# Union of Concerned Scientists

**Subject: San Onofre Unit 2 Steam Generator Root Cause Report and  
Proposed Restart Compensatory Measures**

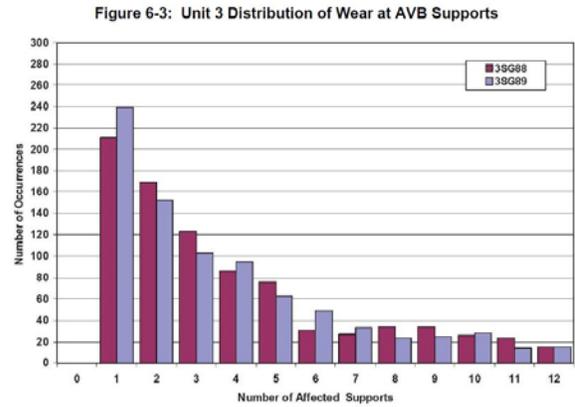
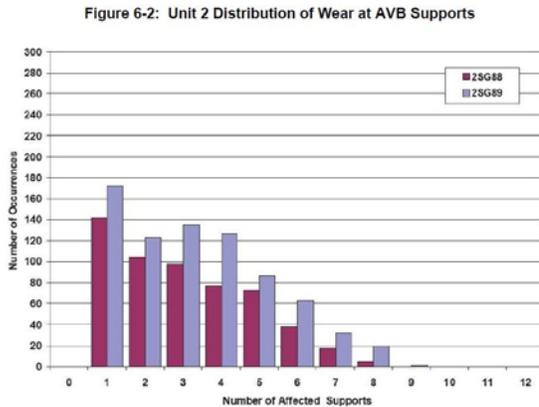
1. Figures 6-2 and 6-3 of Enclosure 2 chart the wear distribution found in the four replacement steam generators. Figure 6-2 presents the data for the two replacement steam generators on Unit 2 while Figure 6-3 presents this data for the Unit 3 replacement steam generators. Figure 6-3 shows that the two replacement steam generators on Unit 3 exhibited similar wear patterns in that the number of wear indications is roughly the same for the number of supports. But Figure 6-2 shows something different. Unit 2 replacement steam generator 2SG89 has significantly more wear indications per number of supports than does replacement

steam generator 2SG88. Until the reason for this marked difference between the wear degradation for the Unit 2 replacement steam generators is understood, the operational assessment performed for future operation is suspect.
